REDEVELOPMENT PLAN 14200 EAST MONCRIEFF PLACE

REDEVELOPMENT PLAN 14200 E MONCRIEFF PLACE COVER SHEET

| NO. | DATE | REMARKS |
|-----|------------|------------------------|
| 5 | 02/12/2021 | 5TH PLANNING SUBMITTAL |

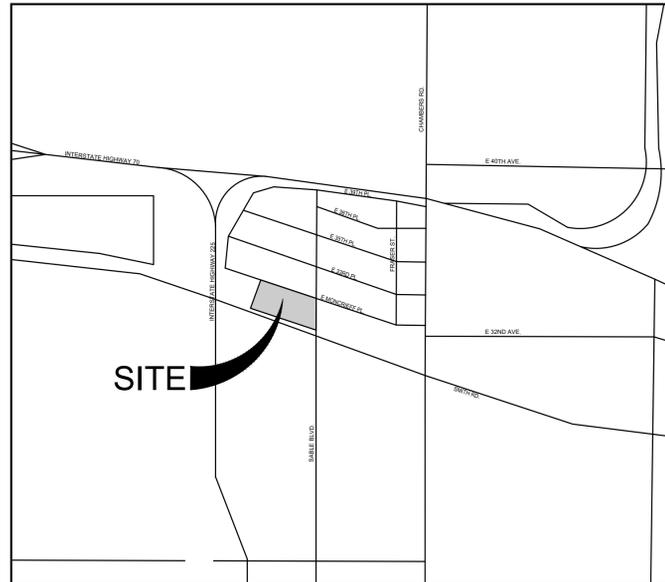
add the plat name here

delete

These comments have been addressed.

SITE PLAN

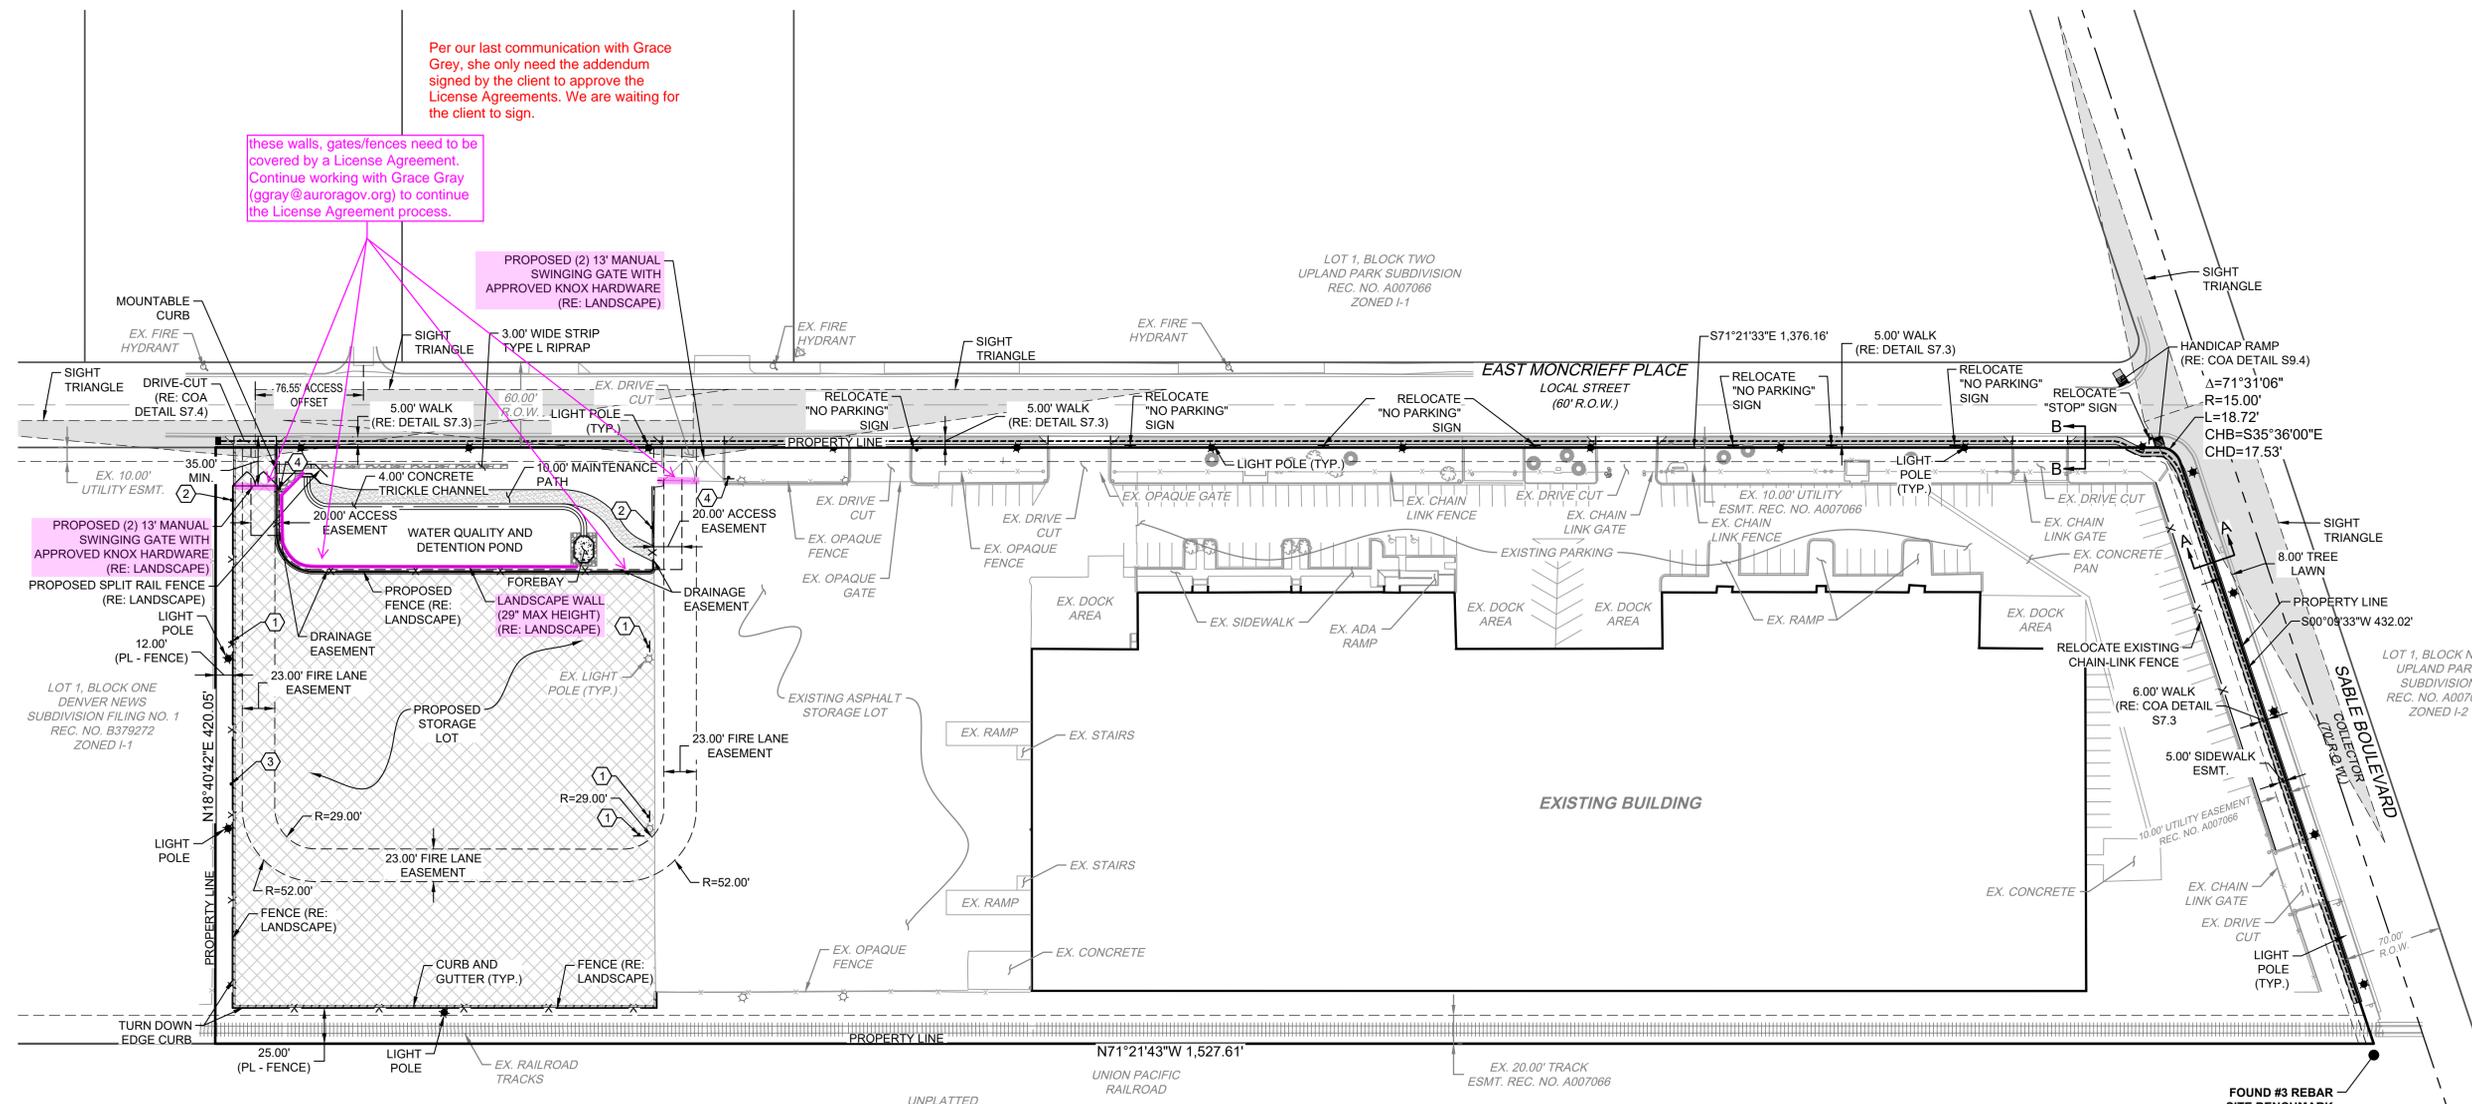
these walls, gates/fences need to be covered by a License Agreement. Continue working with Grace Gray (ggray@auragov.org) to continue the License Agreement process.

Per our last communication with Grace Grey, she only need the addendum signed by the client to approve the License Agreements. We are waiting for the client to sign.
